Observation of misaligned anode grids in production Vacuum Phototriodes

23 December 2004

B W Kennedy
Rutherford Appleton Laboratory

Figure 1. Fraction (%) of VPTs with significantly off-centre anode grids

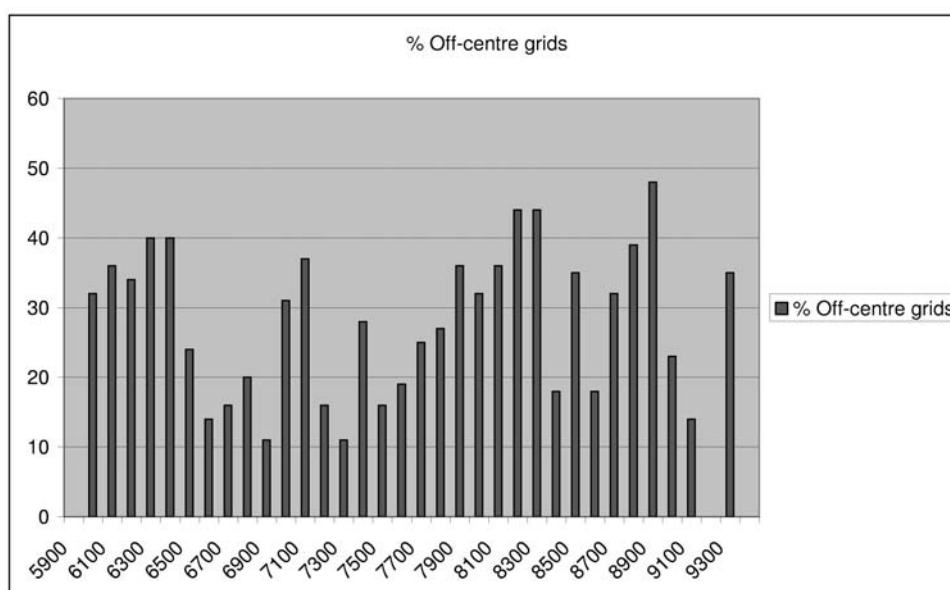
The percentage of tubes with grids significantly off-centre for VPTs with bar-codes from 6001 onwards is shown in Figure 1,. Each bin in the figure represents 100 VPTs. 27.2% of these VPTs have off-centre grids, but large fluctuations are seen over time. For example, the fraction was much lower for VPTs 6601-7600, but higher for devices in the ranges 6001-6500 and 8001-8400.

However, since a misalignment of the grid will inevitably reduce the minimum clearance between components inside the tube, there may be an increased chance of electrical breakdown in the future. For this reason, we have concerns about the long-term behaviour of these VPTs, and would encourage RIE to take steps to improve the grid alignment. We will continue to monitor the affected VPTs, to obtain a better understanding of their long-term behaviour.
